Cycle Chippenham response to PL/2026/01431, Southpoint Business Park (Plot 100), A350 West Cepen Way / B4528, Chippenham, SN15 2NU

Proposal: Erection of health, fitness and racquets club, including three outdoor tennis courts within an enclosed air dome structure, three outdoor padel courts enclosed within canopies, indoor and outdoor swimming pools, outdoor multi use court, outdoor battle box exercise facility, external spa garden, child activity area, lounge facilities including a business hub and terrace, together with ancillary facilities, car parking, servicing, landscaping and associated works.

Cycle Chippenham response

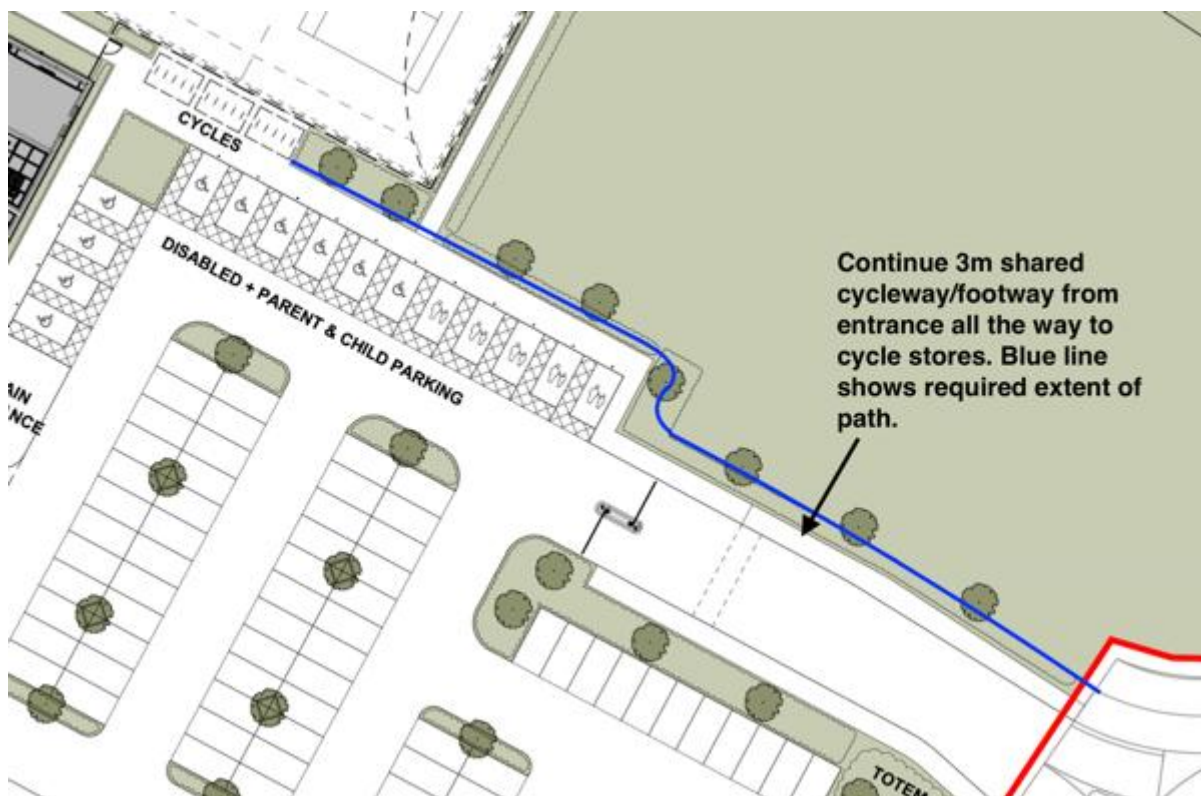
We note the 3m shared use footway/cycleway along the development spine road ends at the applicant's red line boundary. It is unclear what people cycling to the site via this route are expected to do at this point. Rejoining the carriageway on the wrong side would not be safe, nor would it be safe to require them to cross two lanes of traffic so close to a roundabout.

A narrow (1.5m) footway appears to be provided along the north side of the access road from the red line. This needs to be upgraded to provide a continuous and direct cycle route to the proposed cycle parking area, as shown in the annotation below.

Requirement: Widen the footway along the north side of the entrance road, to provide a continuous cycle route from the on-site cycle parking to connect with the cycleway at the red line boundary. Note that the corners need rounding, so that they're not 90°. The planting can be pushed back into the open space to accommodate this, without loss of planting area.
